" Quality Alert "

QA-029

IF5050B24

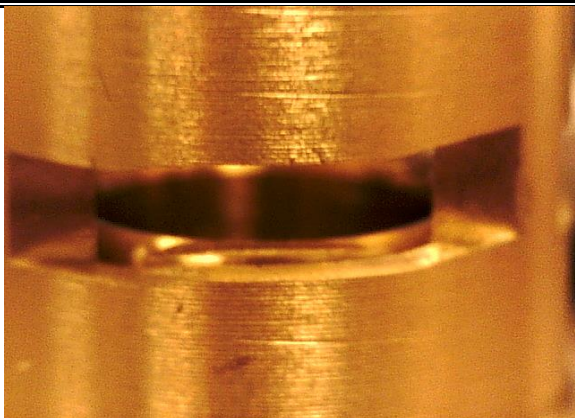
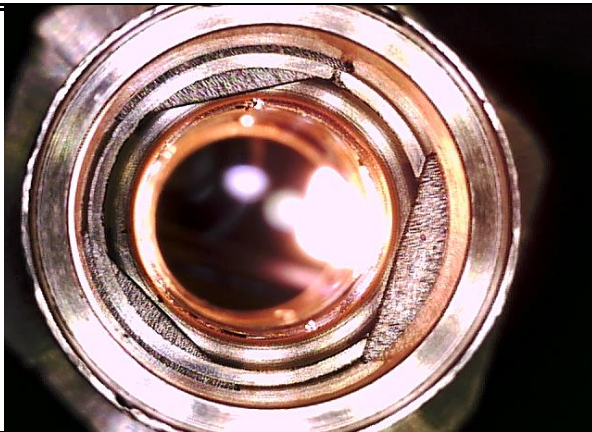
Sealing surface cut/knicked when side holes were machined.

BAD

BAD

100% visual inspect all parts coming off of machine
